DOE/EIS-0387-SA-04
June 2020

**FINAL SUPPLEMENT ANALYSIS FOR THE
FINAL SITE-WIDE ENVIRONMENTAL IMPACT
STATEMENT FOR THE Y-12 NATIONAL
SECURITY COMPLEX, EARTHQUAKE
ACCIDENT ANALYSIS**

Figure 3-1. Minority Population – Census Tracts with More than 50 Percent Minority Population or a Meaningfully Greater Percentage of Minority Individuals in the General Population in a 50-Mile Radius of Y-12.

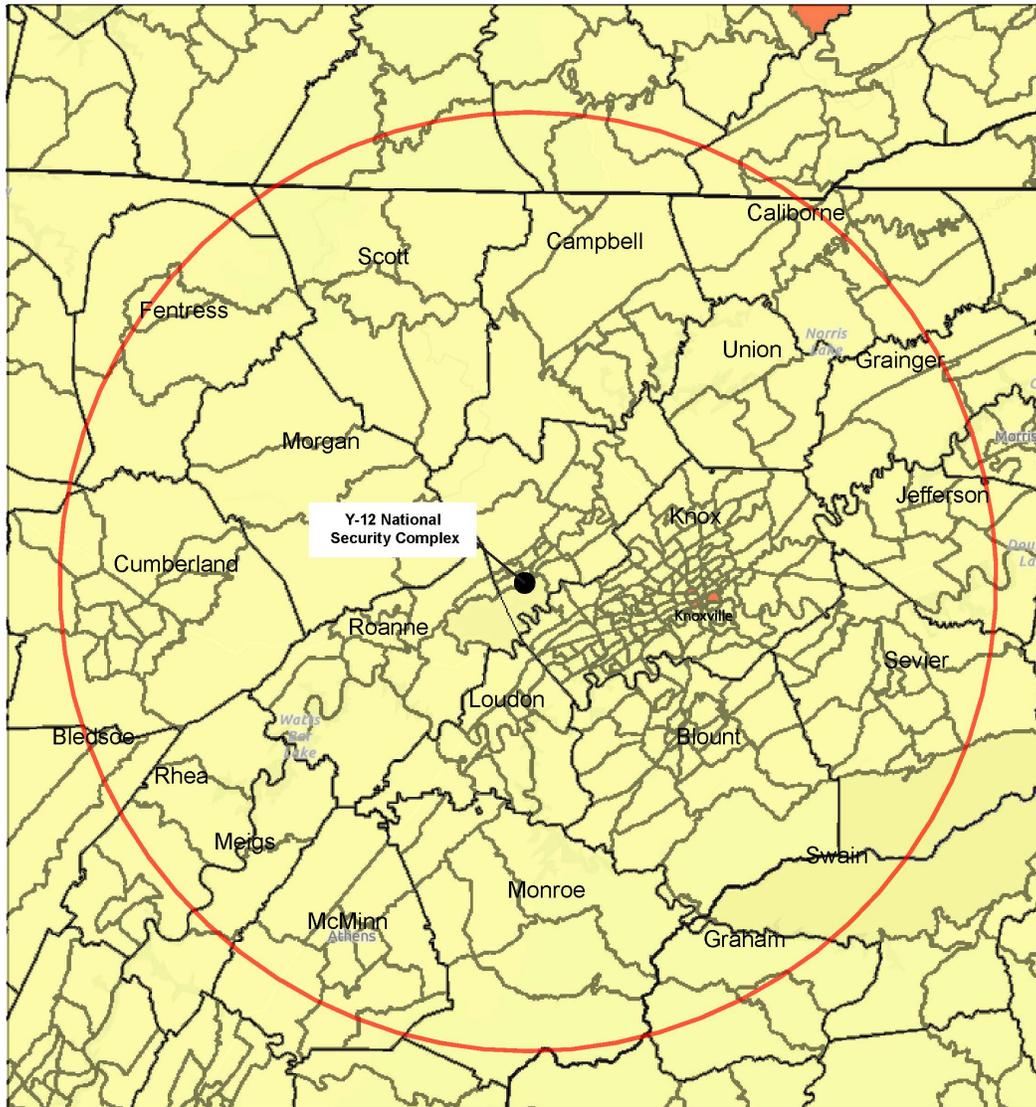
Response: While the titles of Figures 3-1 and 3-2 in the Draft SA only indicated census tracts with more than 50-percent minority and low-income populations, a “meaningfully greater” threshold was also considered in the analysis for this SA. For the Y-12 SA, the threshold used for identifying minority and low-income communities surrounding specific sites were developed consistent with CEQ guidance (CEQ 1997, p. 25) for identifying minority populations using either the 50-percent threshold or a “meaningfully greater” percentage of minority or low-income individuals in the general population. For this SA, meaningfully greater is defined as 20 percentage points above the population percentage in the general population. The potentially affected area considered is the area within a 50-mile radius of Y-12. The State of Tennessee was used as the reference community to determine “meaningfully greater” thresholds. The average minority population percentage of Tennessee is 26 percent and the average low-income percentage is 16.7 percent (USCB 2020a). The thresholds for minority and low-income populations are presented below:

While using this threshold it was determined that the nearest minority and low-income populations that exceeded these thresholds were located approximately 15 miles east of Y-12 (EJSCREEN 2020). The titles of Figures 3-1 and 3-2 have been revised to accurately reflect the census tracts with more than 50-percent minority and low-income populations, as well as a meaningfully greater threshold.
